CITY OF ALBUQUERQUE

RE: McMahon Market Place – Lot 9B, 9C, & 9D Improvements

Conceptual Grading and Drainage Plan

Hydrology File: A11D011I

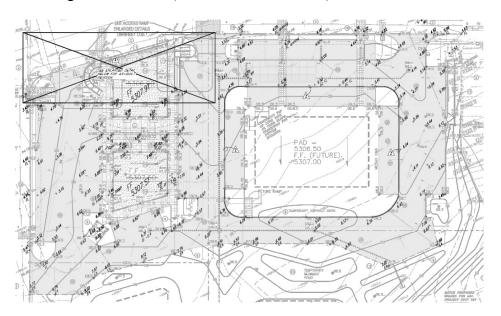
1. Hydrology needs a new topo survey of the area. The information provided by the architect was done almost 7 years ago and the whole area has been disturbed. (see photo)

CONCEPTUAL GRADING & DRAINAGE PLAN (NOT FOR CONSTRUCTION)

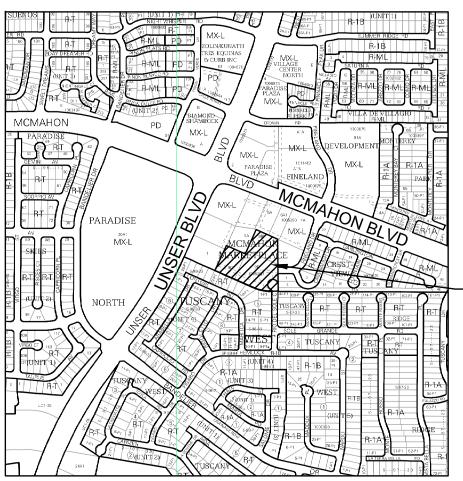
2. Also there is currently storm drain system that Lots 9C & 9D are to tie into based on the last design for this area. (see As-built for Lot 9A)
